CONSTRUCTION SUMMARY

Lindsay 2017 Developments Inc. / Sugarwood

Lot/Unit: 20 Phase/Building: 2 Model/Floor Plan: Lovesick Lake (3705) Elev A 4Bed 2.5Bath

SKETCH #1

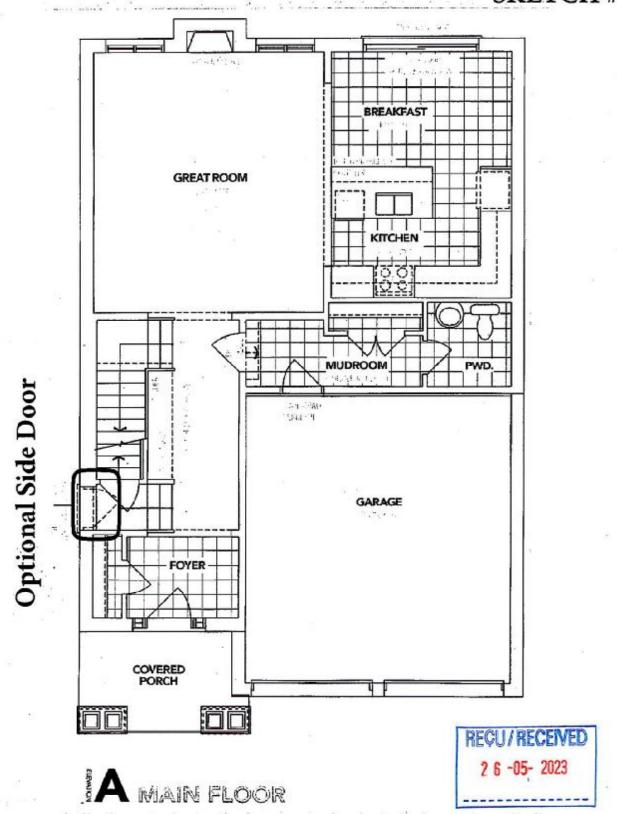
Inv. 6255	1 - TO SUPPLY AND INSTALL OPTIONAL SIDE DOOR TO THE HOME SEE SKETCH #1	
Line 79084	Note:	
26May23 / 26May23		
Inv. 625 5	3 - TO SUPPLY AND INSTALL UPGRADED BASEMENT WINDOWS (36X24") IN LIEU OF THE STANDARD SEE SKETCH #2	
Line 79086	Note:	
26May23 / 26May23

SKETCH #2

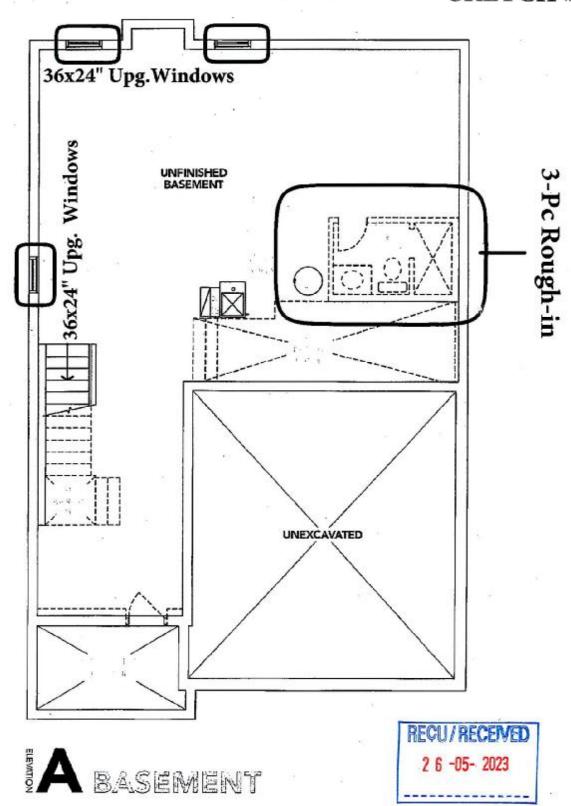
Inv. 625 5	1 - TO SUPPLY AND NSTALL 3-PC ROUGH-IN IN THE BASEMENT SEE SKETCH #2	
Line 79085	Note:	
26May23 / 26May23
